Amendments to the Drawings

Title: Inventors: 09/872,596 Virtual Network Devices

Dennis P.J. Ting, et al. Annotated Sheet

FIG. 2

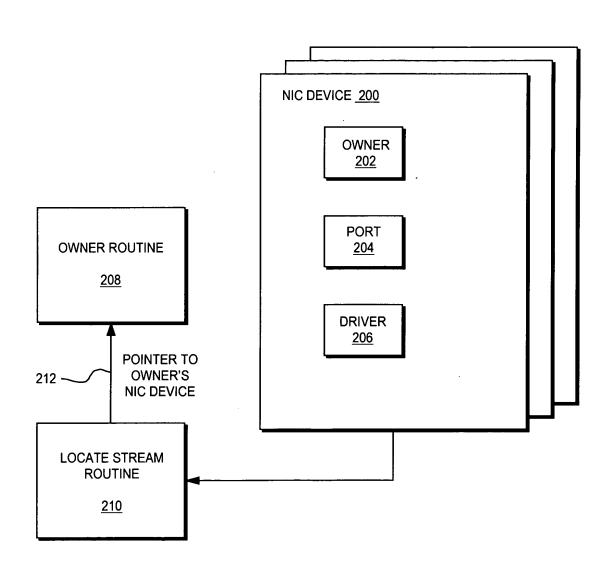
In Fig. 2, the reference number 140 is replaced with the reference number 142. Support is

found in the original specification at page 8, lines 11-15 among other teachings throughout the

FIG. 6

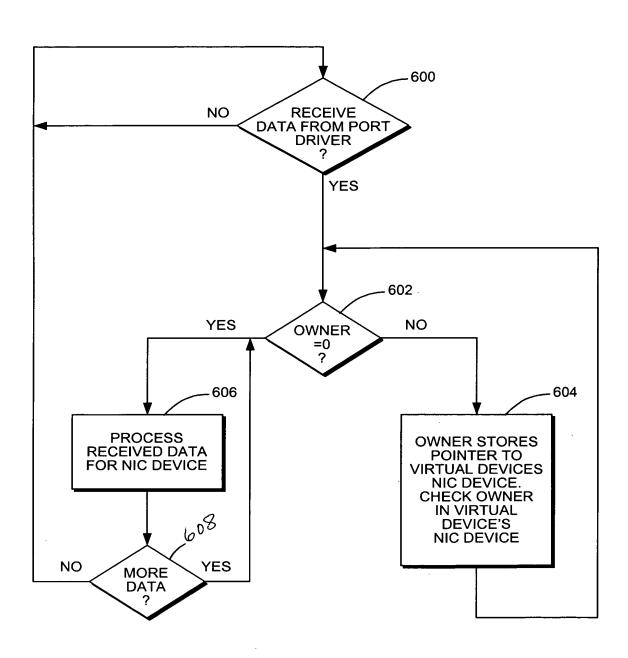
In Fig. 6, the decision symbol containing the text "MORE DATA?" is labeled with

reference number "608". Support is found in the original specification at page 18, lines 8-11
